Revision	Description	Date
A	Initial Release	?
B	As built changes: E990211-00-C	5/99
C	1. Added compensation networks to coil drivers with capacitors, Cadd1 through Cadd10 and resistors Radd1 through Radd5 2. Changed coil driver 183 ohm (R202, R216, R229, R243, R256) to 125 ohm, 2 Watt for ITMX and ITMY and to 183 ohm 1 watt on all other chassis. 3. Cadd11 through Cadd14 added to board to stabilize and limit high freq gain of 1Hz zero, 40Hz pole compensation stage. 4. Dadd1 through Dadd20 added to coil driver for op amp input protection.	2/00

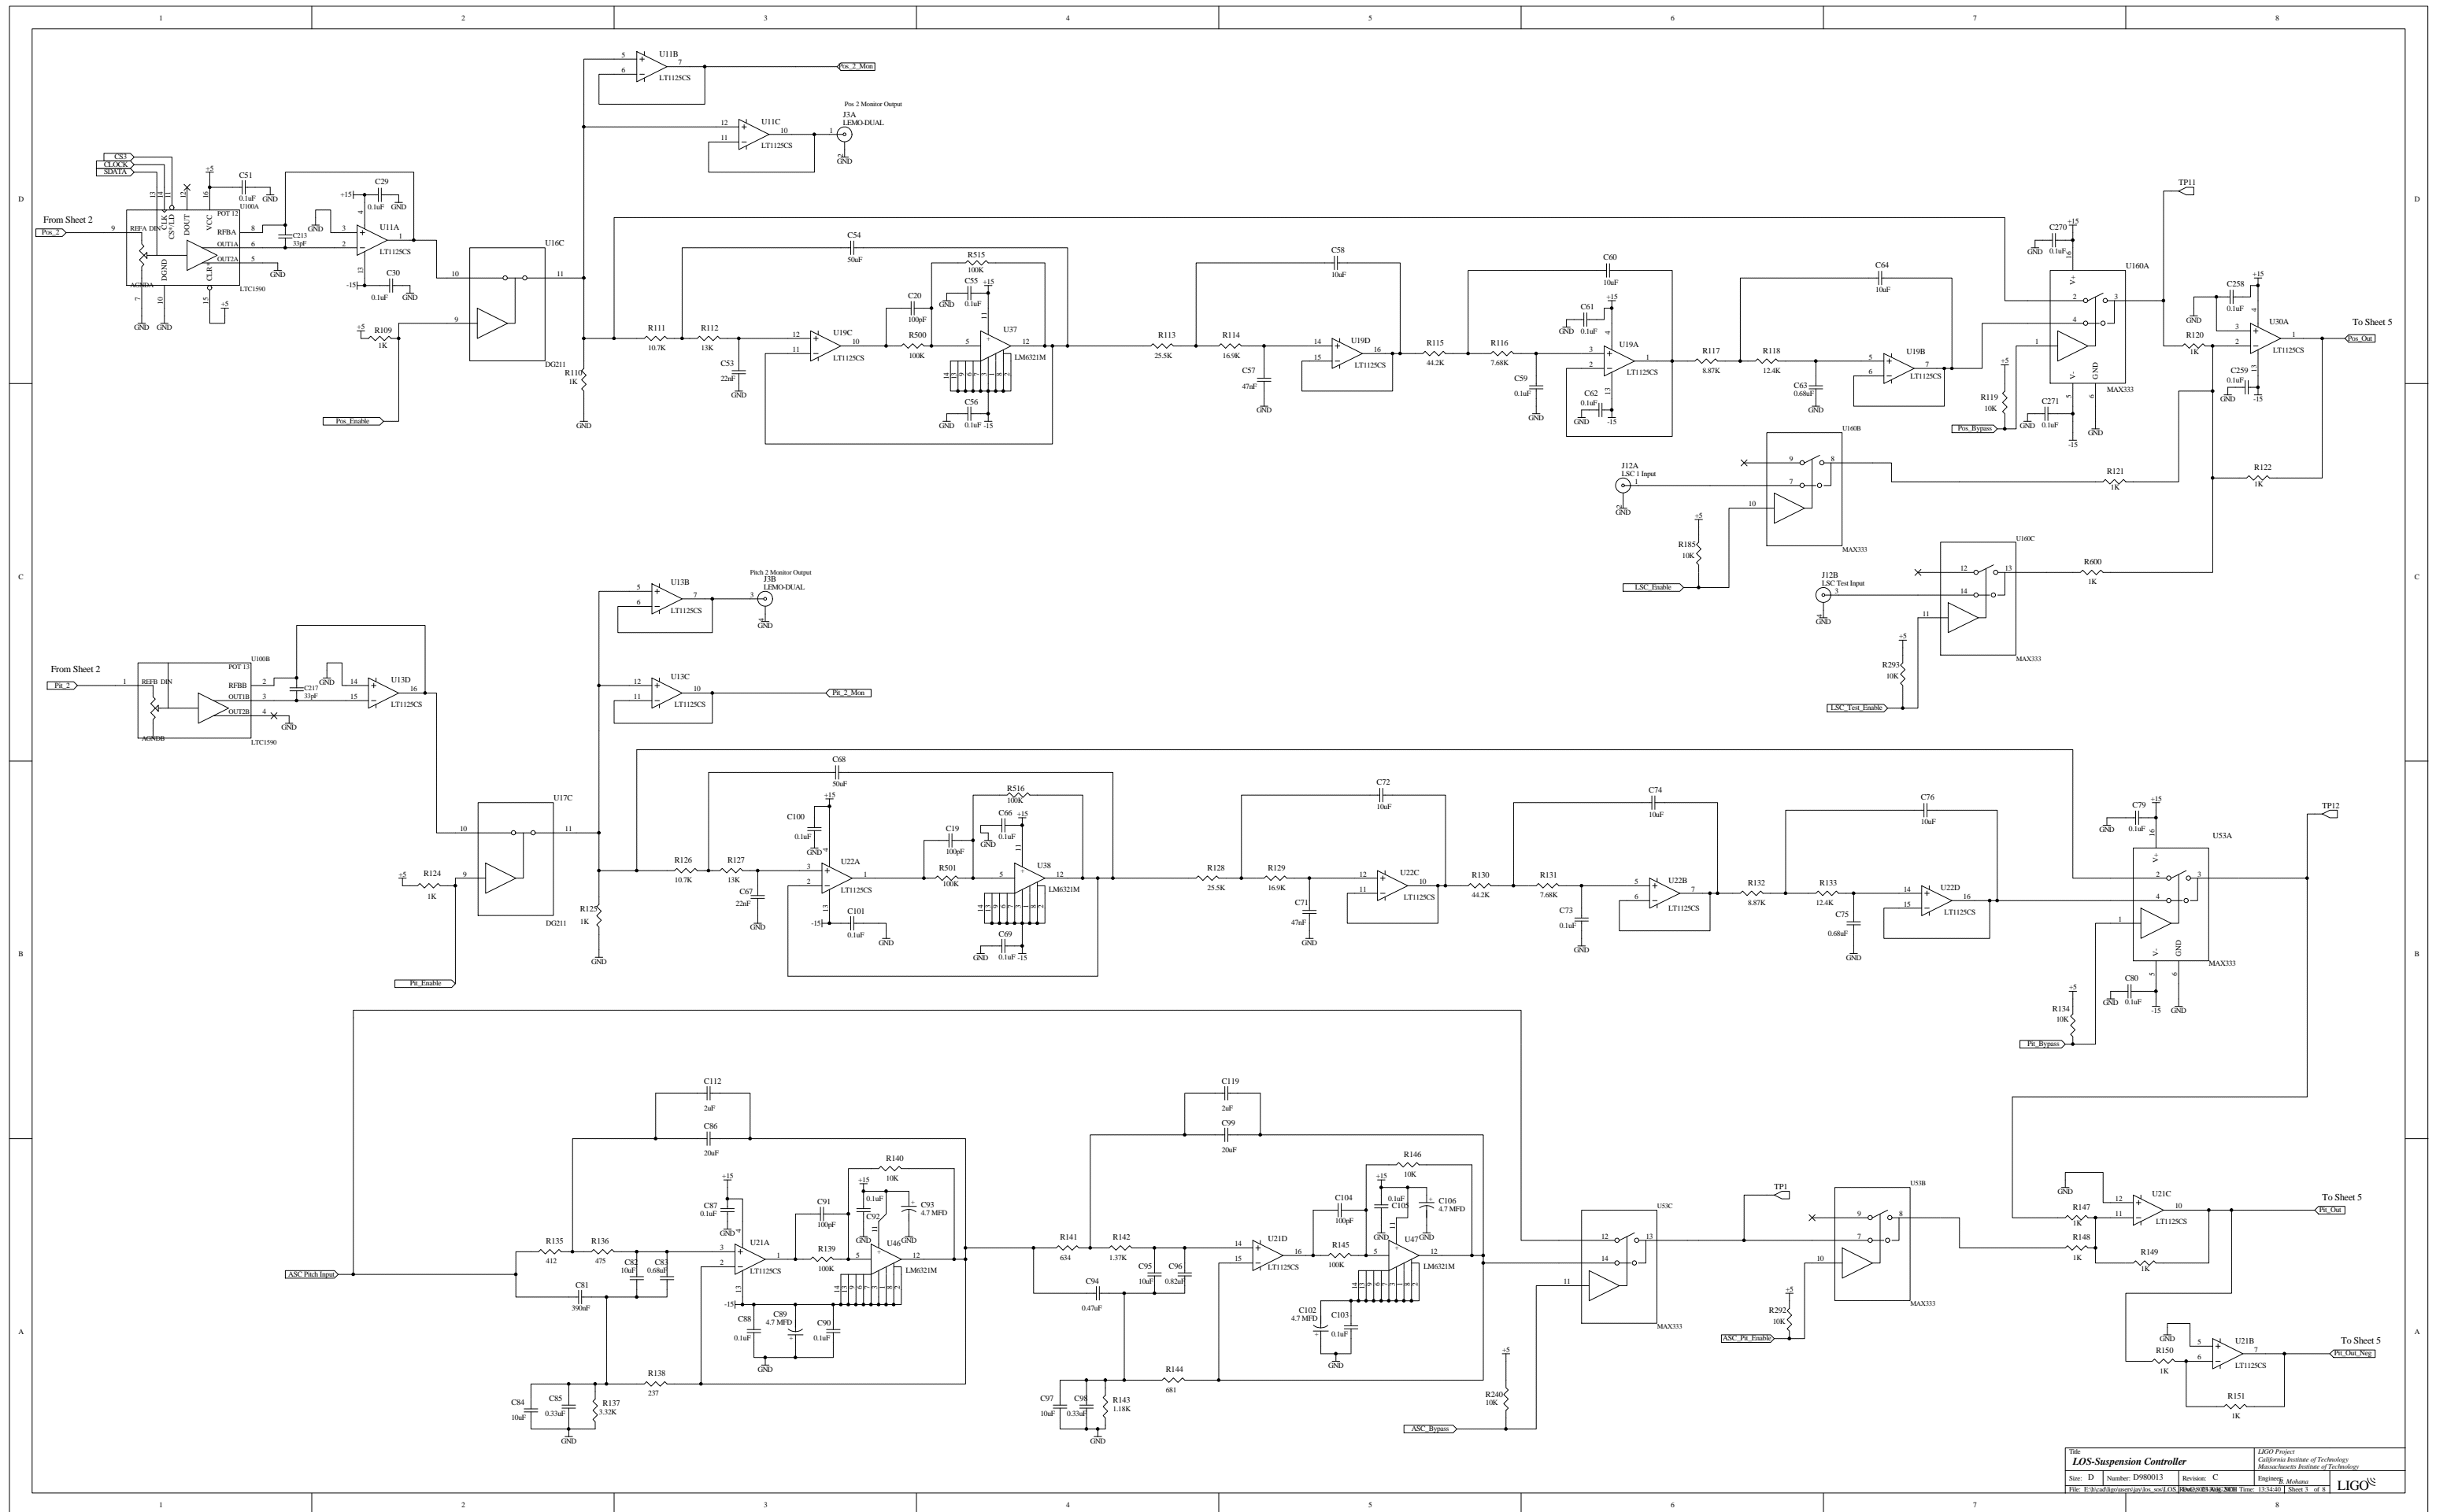
Note: 402 ohm resistor and 10uF capacitor are not stuffed on LOS controllers for the RCM and BS.

Note:  
402 ohm resistor and 10uF capacitor are not stuffed on LOS controllers for the RCM and BS.

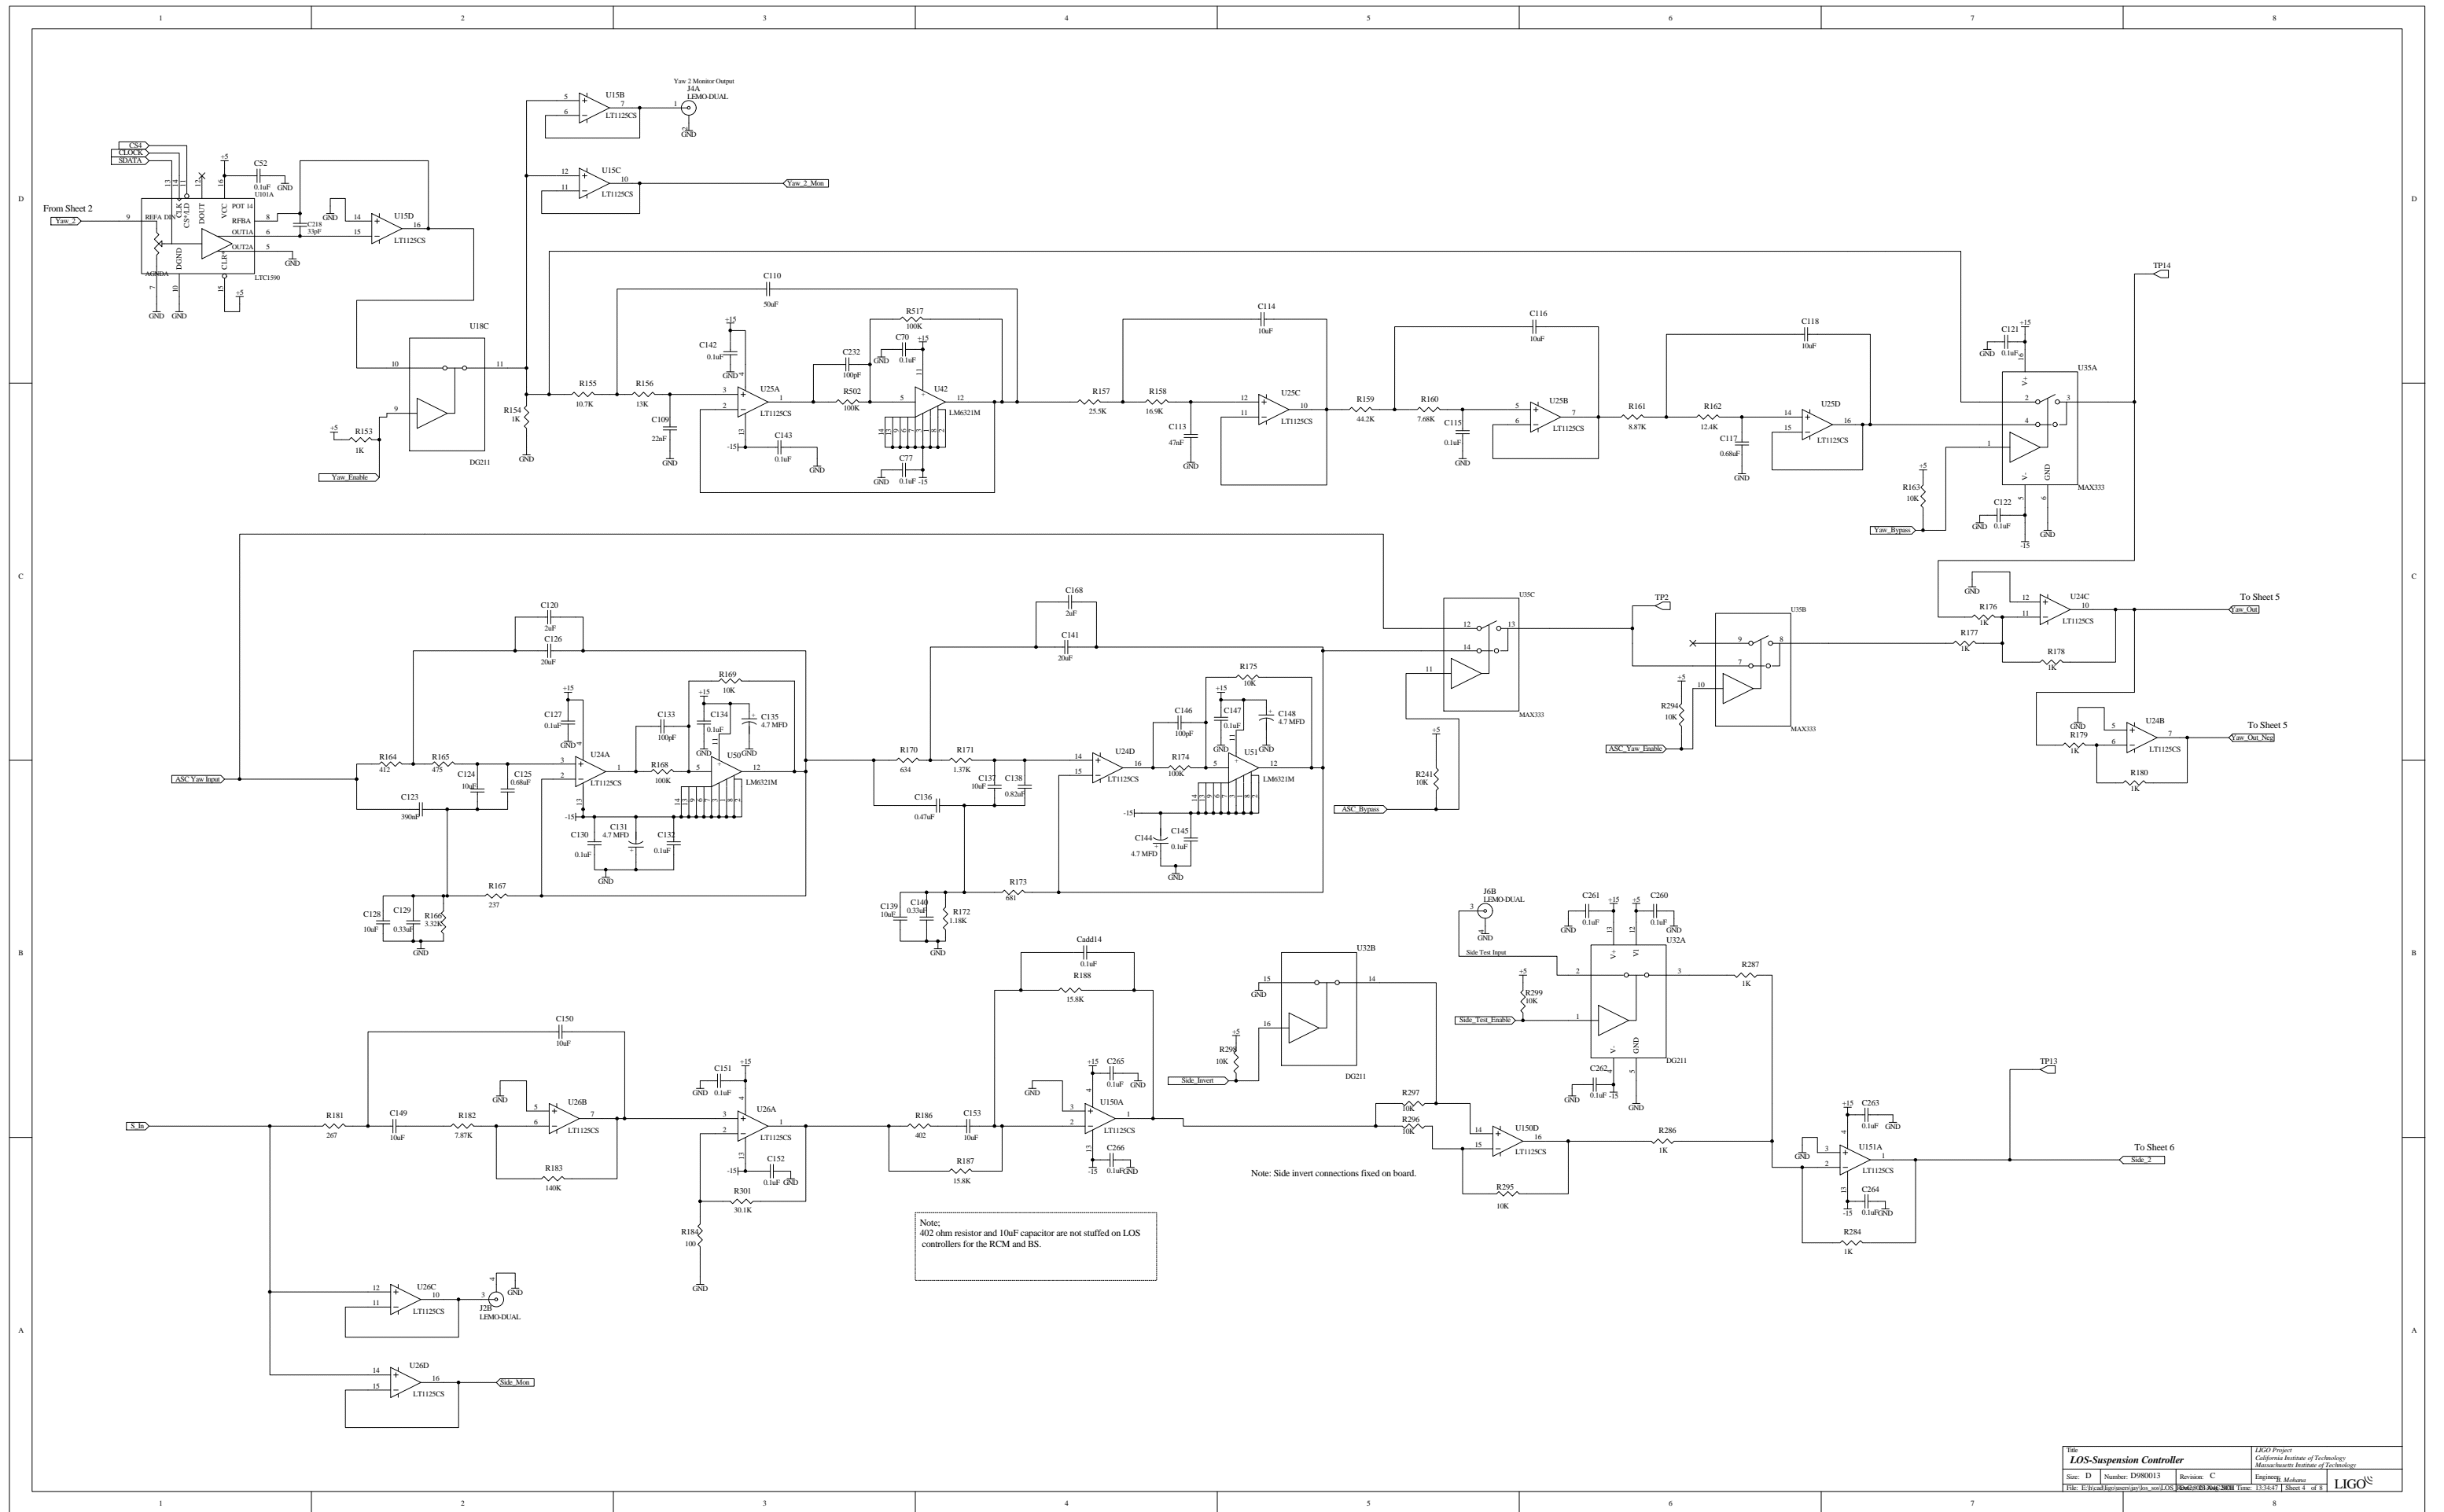
Note:  
402 ohm resistor and 10uF capacitor are not stuffed on LOS controllers for the RCM and BS.

Note: Side invert connections fixed on board.
